223 12th Avenue East

Recommendation Packet | East Design Review Board | SDCI Project #3025863 | November 08, 2017

Street View looking Northwest

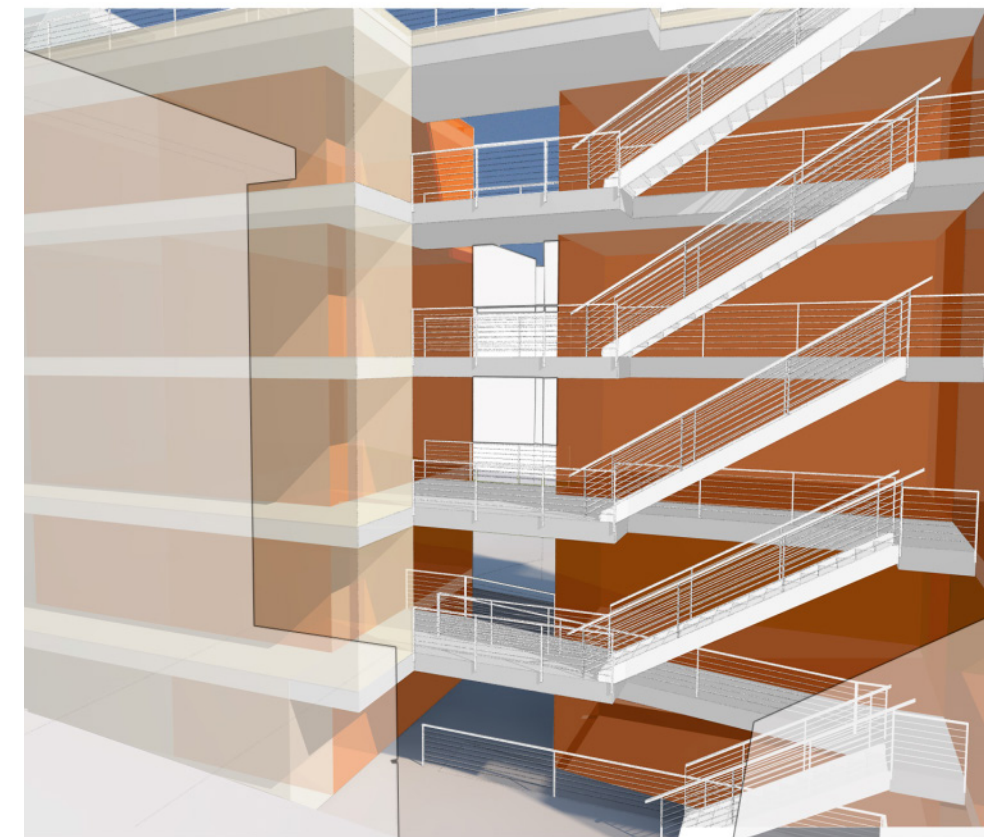
The Board was generally supportive of the street oriented 'living (entertainment) room' at ground level. The Board liked this placement as they did not feel that a living unit along 12th Ave would be appropriate. The Board liked the planter located in front of the entertainment room that helps in creating a sense of privacy while still engaging with the street. (CS2-B, CS2-I, PL2-I-i)

The Board felt that as the project design evolves, the applicant should work towards activating the entertainment space in a thoughtful manner. (PL1-C, DC1-A-1, DC3-B)

The Board noted that the service area should be configured in a manner that provides an opportunity for overflow activity from the 'living room' to the outside areas. (PL3-B, DC3-I)

- The community room (“living room”) has been located off of the lobby and faces the sidewalk and 12th Avenue E. The board agreed that this was a great location for this space as a residential unit would not be appropriate here.

- Accommodates small groups or one or two people seeking internet access to a place for study and entertainment.
- Oriented to engage the streetscape of 12th Avenue.

- Open the community room to the sidewalk for the full width of the facade.
- Results from decision to shift egress stair away from street facing facade.

- Also results in residential units across the entire facade above the first floor.
- The improvements to the front facade and sidewalk outweigh the desire for windows to the west and south for the community room.

- Orientation of the stair at the interior of the site results in no windows permitted to the south and west of the community room due to an egress corridor adjacent to the exterior walls.

Courtyard View Looking Southwest

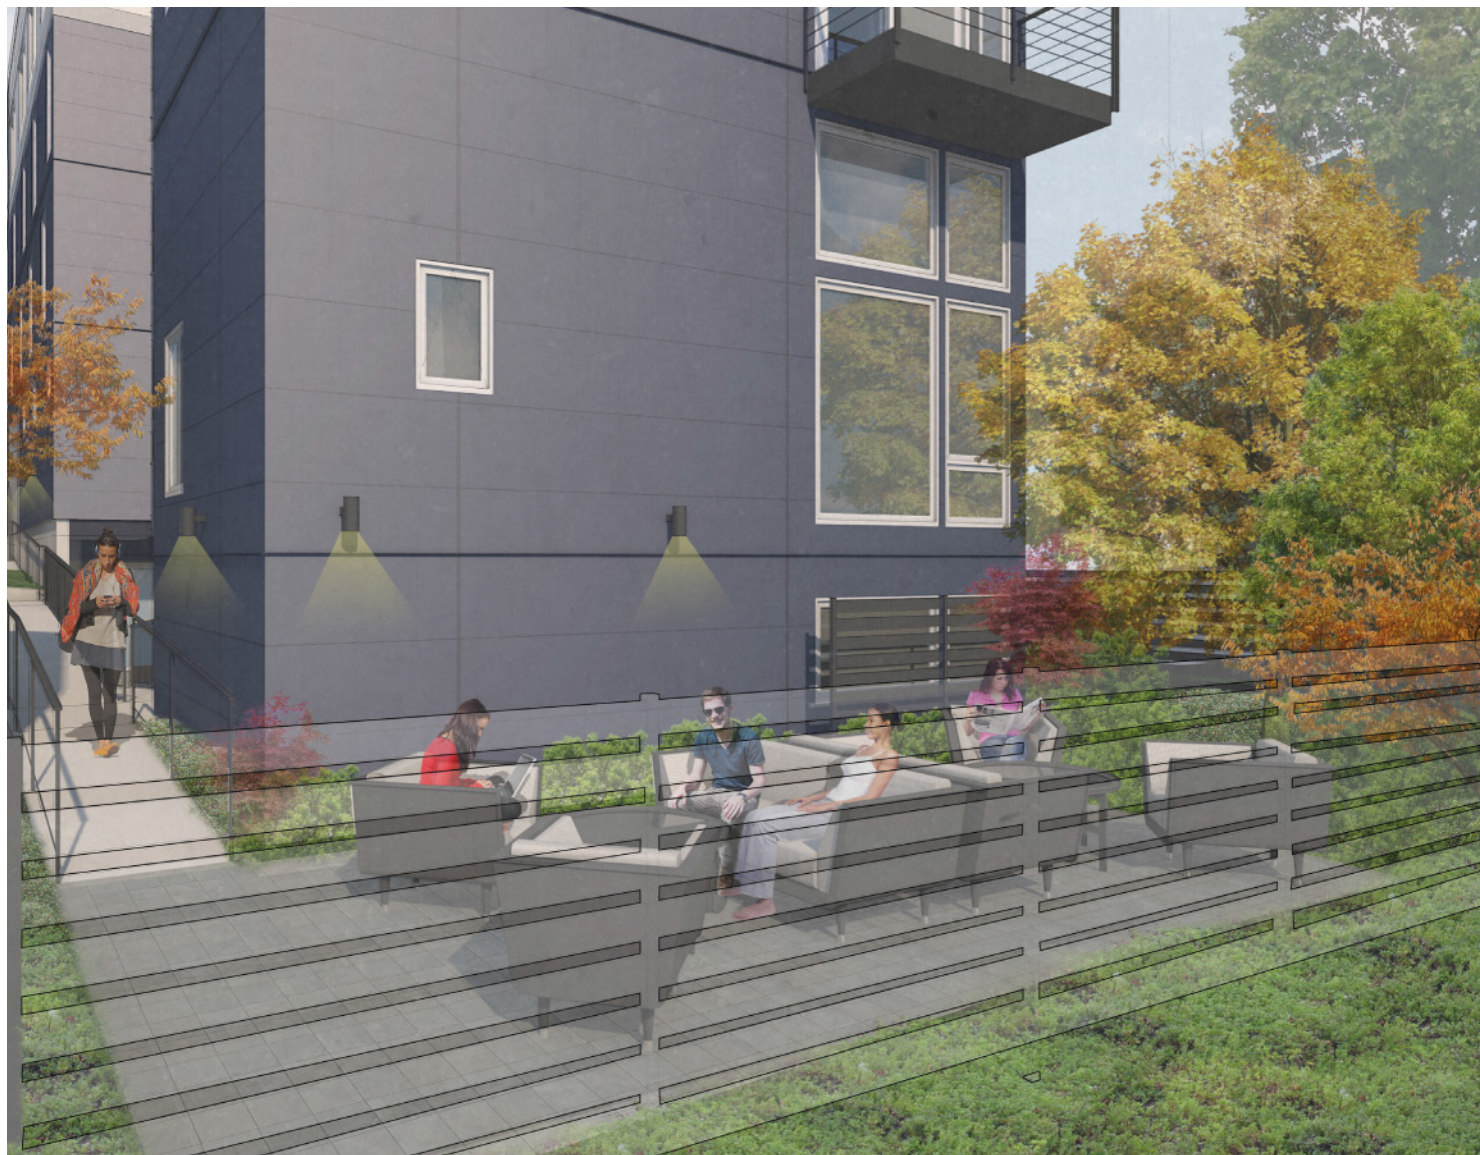
The Board liked the views to the north courtyard from the ground level pass-through and felt that it could become an interesting space that could be a usable area in conjunction with the visual component of the open stair. The Board also appreciated the small scale trees and shrubs used as a buffer between the neighbor's property to the west. (CS2-B, PL1-C, DC3-B)

The Board verbalized that at the next meeting, they would like to know details regarding the pavers, landscaping and other elements to get a feel of what the might be like and how it might be used. (DC1-II, DC2-D-2, DC4-I, DC4-A)

The Board would also like a better understanding of how the north courtyard and south courtyard are in relationship to the entertainment area and trash area worked and wanted to the material details and the possibility for more landscaping. The Board said that they wanted to see renderings and perspectives of these spaces to get a better feel how these spaces will be used. The Board also wanted to see a view from the sidewalk through the common area specifically as well as better clarity of the front of the building at the ground floor level. (PL2-I-I, PL3, DC1-II)

- The amenity area/courtyard strategy has evolved slightly since EDG.
- The presence of groundwater on site resulted in a shallower excavation to reduce construction impacts from the shallow water below grade.
- As a result, the space at the rear of the site has been developed to provide a shared patio to complement the courtyard internal to the project. The patio is accessible via a ramp from the courtyard and a gate from the sidewalk.
- This strategy provides a variety of outdoor spaces at grade for the residents.
- Both spaces will feature a mix of planters or landscape and hardscape.
- In addition a large roof top deck is provided with several sitting areas oriented to the south and west.

East Rendered Elevation

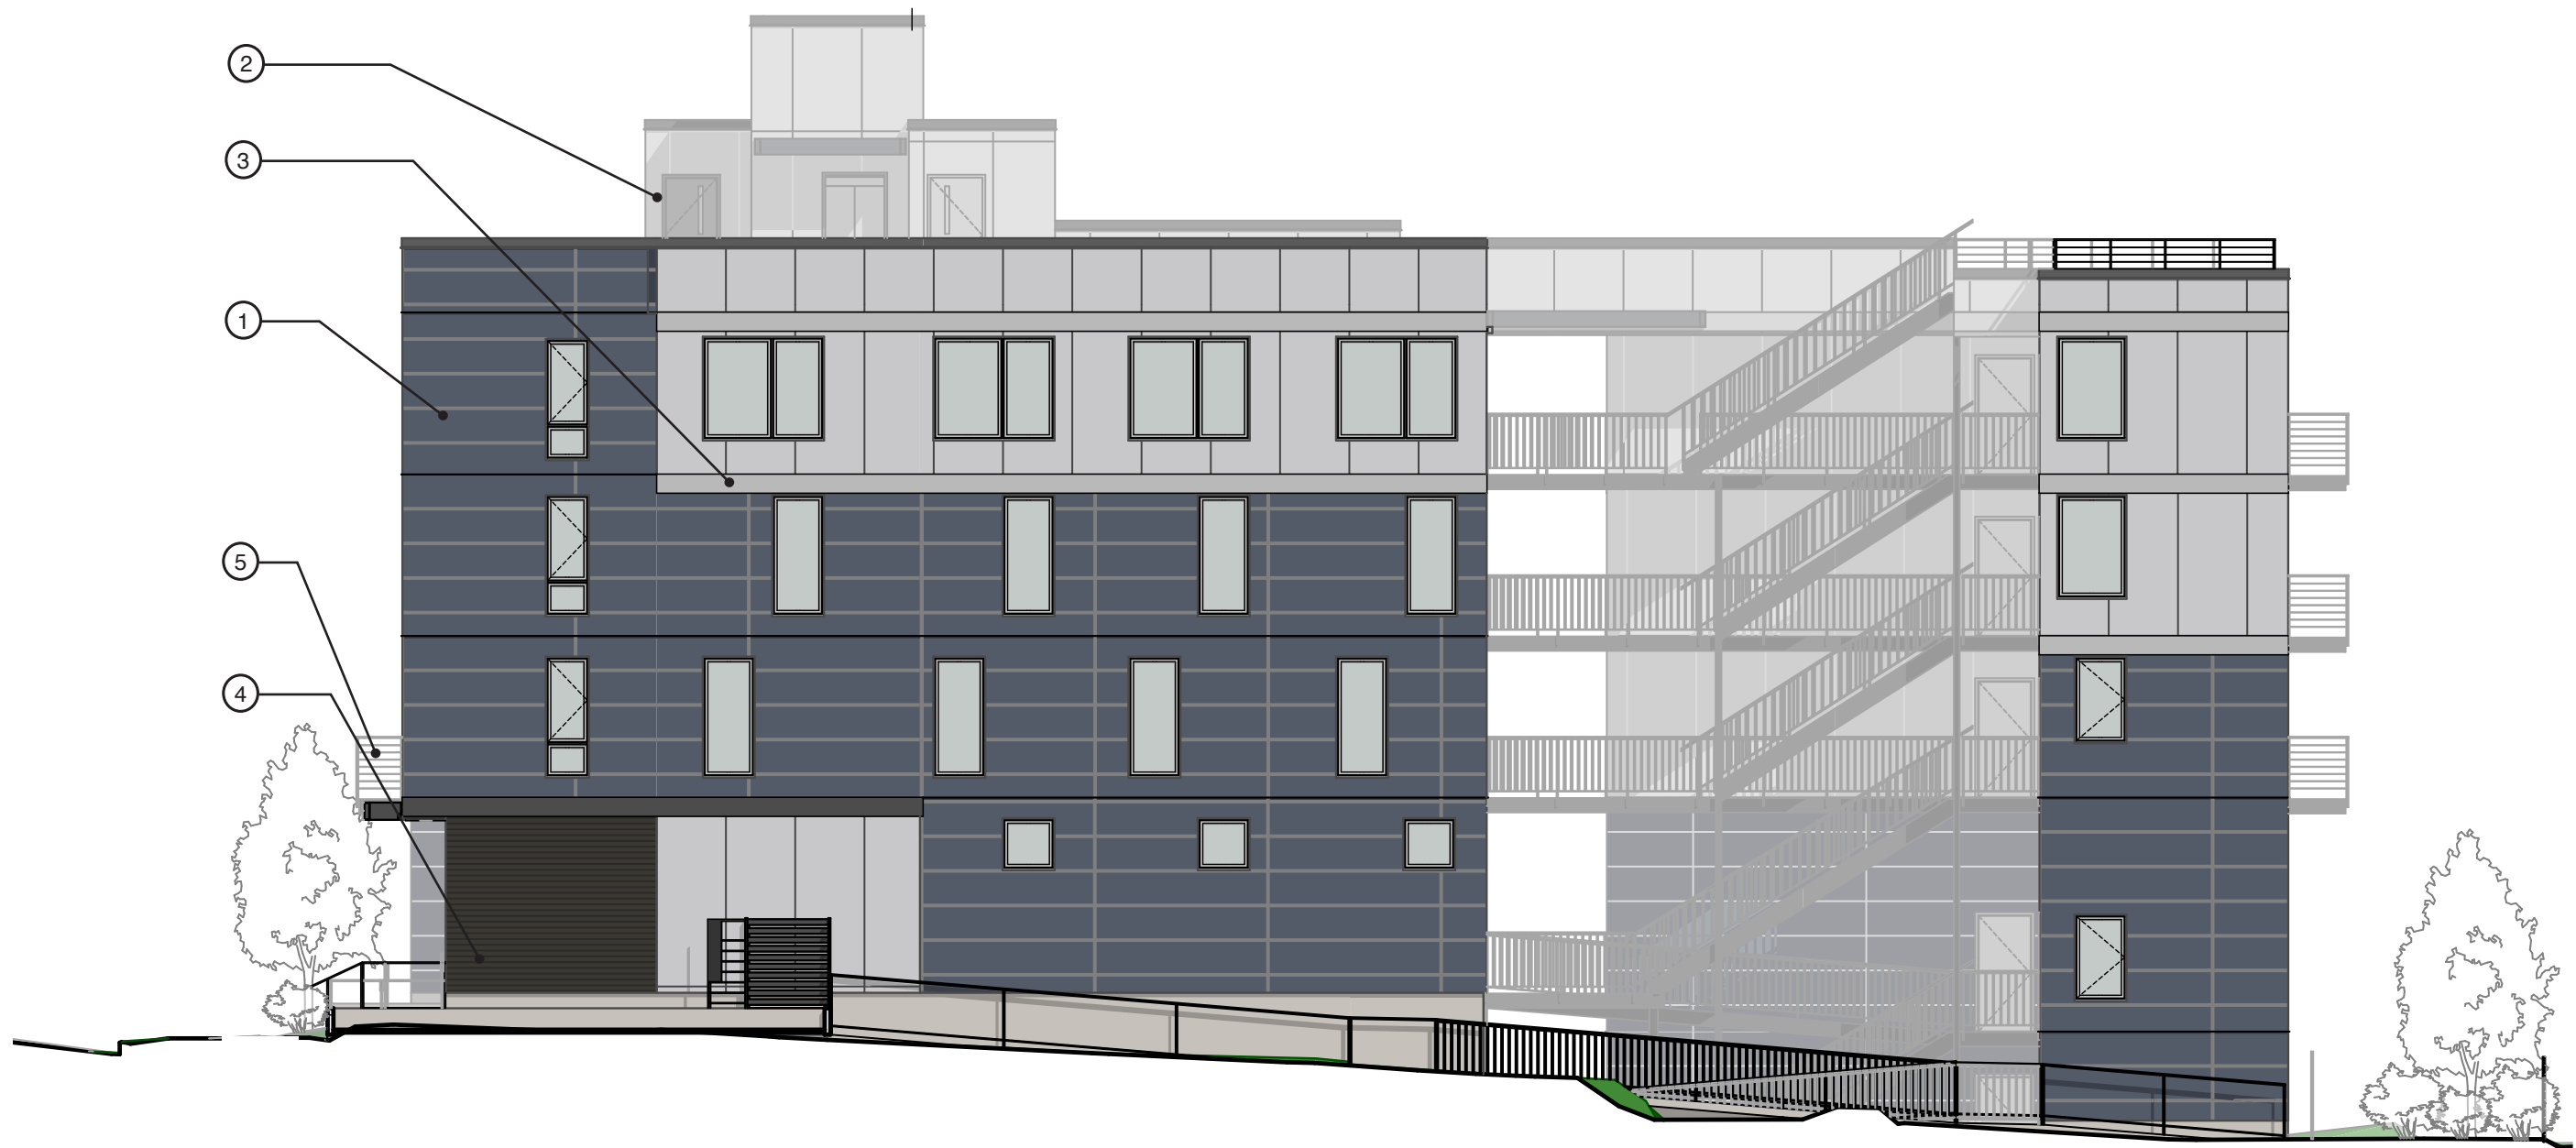
The Board generally agreed with the scale of materials to be used on the exterior of the project. (DC4-A, DC4-I)

The Board advocated for the use of materials that have texture, scale and potential for shadow lines while stating that materials should be elegant and as well as understated. (DC4-I, DC4-A, DC2-D, DC4-II)

The Board stated that proportionally the windows seemed small and there might an opportunity to explore the massing of the front entry bump out and its relationship to window placement and sizing. DC4-I, DC4-II

To add scale to the structure, this modern design approach uses durable materials in a manner consistent with the neighborhood.

- Clad in various sizes and tones of fiber cement board to create a mix of textures and surfaces.
- 12th Avenue facade includes a variety of colors and materials to delineate uses and openings.
- Areas of wood siding highlight the entry from 12th Avenue E.
- Windows have been enlarged in response to the Board guidance.
- Modulation has been added at the 12th Avenue facade to better articulate the building entry and add more visual interest and scale to the facade. An additional departure has been requested for this massing projection.

← Design proposal at EDG meeting Design proposal evolution since EDG meeting →

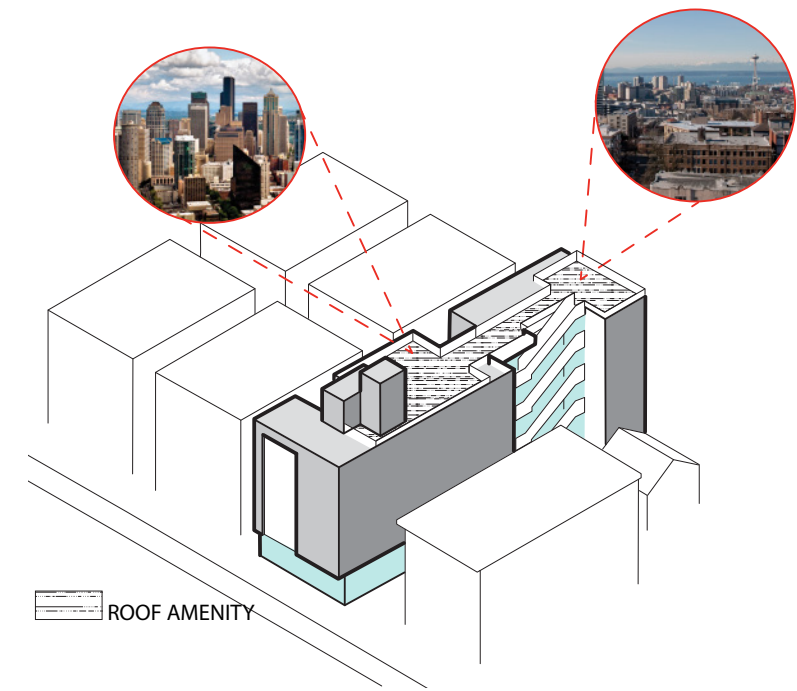
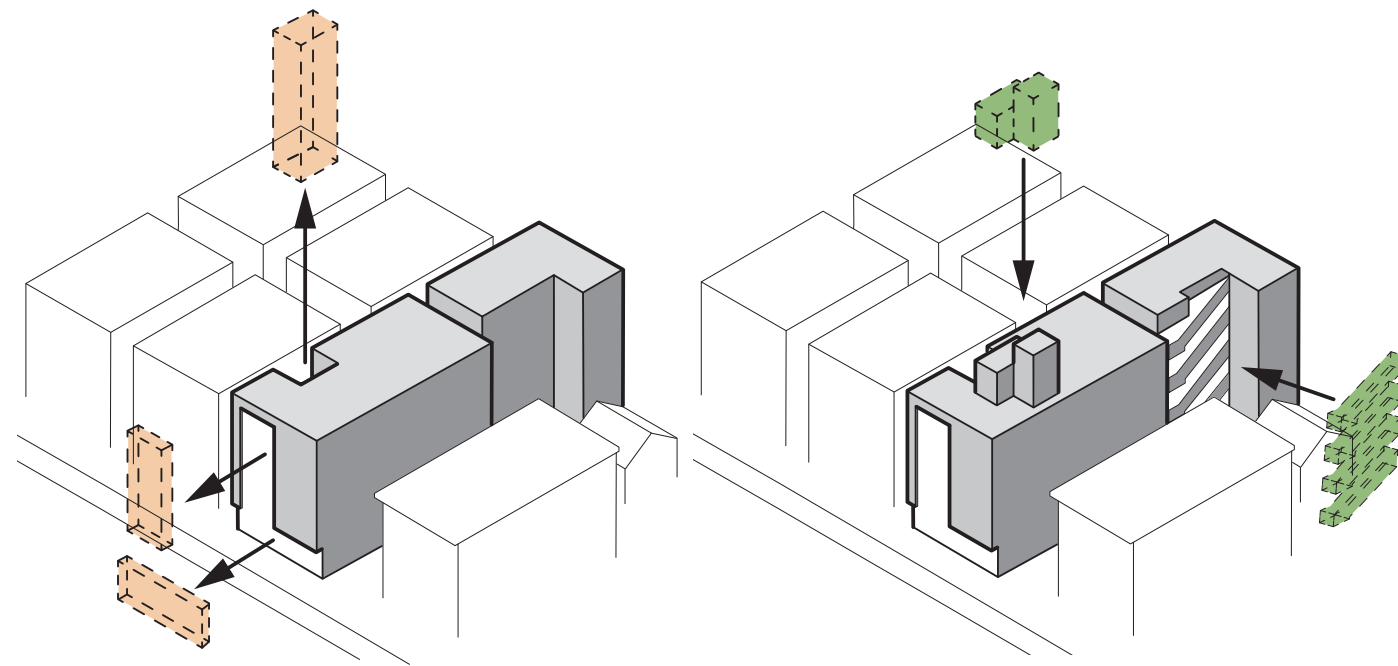
The Board was generally supportive of the preferred massing Option 3 in terms of height, bulk and scale, as this option gives a much more dynamic feel to the site than the other two options. Board members agreed that Option 3 presents a dynamic solution to what otherwise could have been a block design. The Board also agreed that Option 3 was the best approach in reducing impacts to the adjacent properties. Board member further stated that this option is also the best solution in terms of setbacks. Finally, the Board verbalized that they liked how all of the units were aligned to receive southern light exposure and appreciate how each unit had more than one exterior wall. (CS2-B, CS2-D, DC2-D)

The Board expressed concern that the see through open stair configuration could be impacted by weather conditions as residents in the rear units would have to go outside to gain access to their units. The Board suggested that as the project progresses, the applicant should consider extending the overhead protection as mitigation. (CS2-3, PL2-C, DC2-D)

- The board was supportive of the massing presented at the Early Design Guidance meeting.
- The design has evolved maintaining the approach to massing elements.

- All residential units have southern exposure and at least two exterior walls.
- The proposed plan is still very dynamic resulting from the initial support of the board for the departures requested at EDG.

- The exterior walkway/stair remains at the center of the site and is used to reduce the overall mass of the proposed structure.
- It is generally oriented with its open side to the north. This protects it from the predominant wind and weather (which comes from the southwest in Seattle) on all floors.

- The exterior walkway/stair area is covered from above by the next floor up and the roof of the structure to maintain a pleasant space for residents.
- The interior elevator/stair penthouse provides an indoor route to the roof deck.
